March 21, 2024

PROJECT NAME: SELF STORAGE - OCALA

PROJECT NUMBER: 2023050138

APPLICATION: MAJOR SITE PLAN #30953

SHEET TITLE  
**C-501**

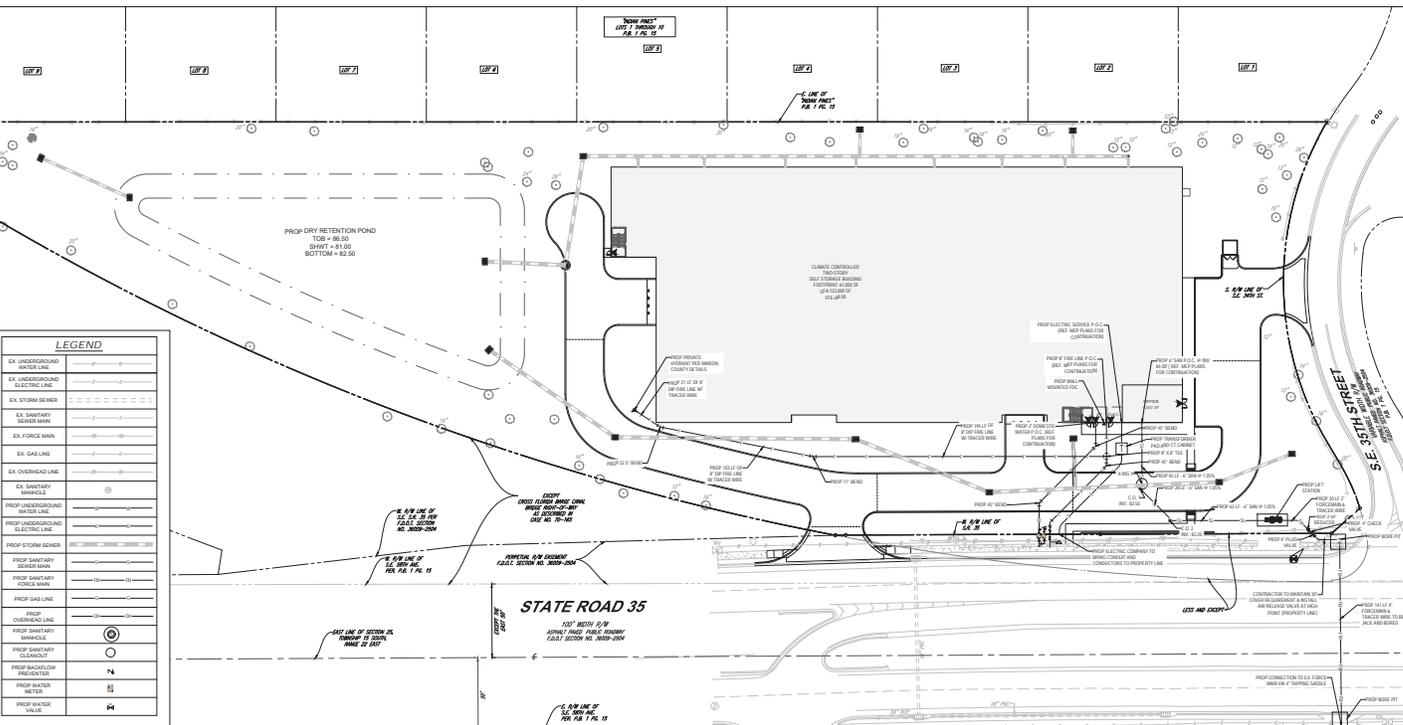
REMARKS: Sheer C-501: 1. call out plug valve to be 316SS 2. keep prop bore pit onsite. 3. callout 48" cover over force main. 4. forcemain crossing can be 2" HDD, cased. Revise/callout. 5. north of the lift station, adjust the fittings to be within the property boundary before crossing SR 35. 6. no 90\* bends in sewer force main; adjust to 2x45\* 7. FM crossing calls for jack & bore. FDOT must approve, otherwise must be directional drill. Need P+P for drill, material to be used, depth, etc. 8. May require ARV on both sides of SR-35.

- 51 DEPARTMENT: UTIL - MARION COUNTY UTILITIES  
REVIEW ITEM: 6.14.7 - Construction Inspection - PLAN NOTE:  
STATUS OF REVIEW: NO  
REMARKS: Sheet C-501 Note 2 - change to ""MCU personnel are to inspect any work performed on or around existing MCU infrastructure. A pre-construction meeting is required to be held a minimum of 48 hours prior to start of any construction. If the pre-construction meeting is not completed, any work may be halted. To schedule, contact MCU's Construction Officer at 352-307-6163."

- 54 DEPARTMENT: UTIL - MARION COUNTY UTILITIES  
REVIEW ITEM: Additional Utilities comments  
STATUS OF REVIEW: NO  
REMARKS: Sheet C-501 General Note #1 - revise note that all onsite water & sewer behind property line will remain under private ownership.

- 55 DEPARTMENT: UTIL - MARION COUNTY UTILITIES  
REVIEW ITEM: Additional Utilities comments  
STATUS OF REVIEW: NO  
REMARKS: Sheet C-501 (1) Sewer Note #5 - connection will be wet tap into existing force main (2) Where are force main notes?
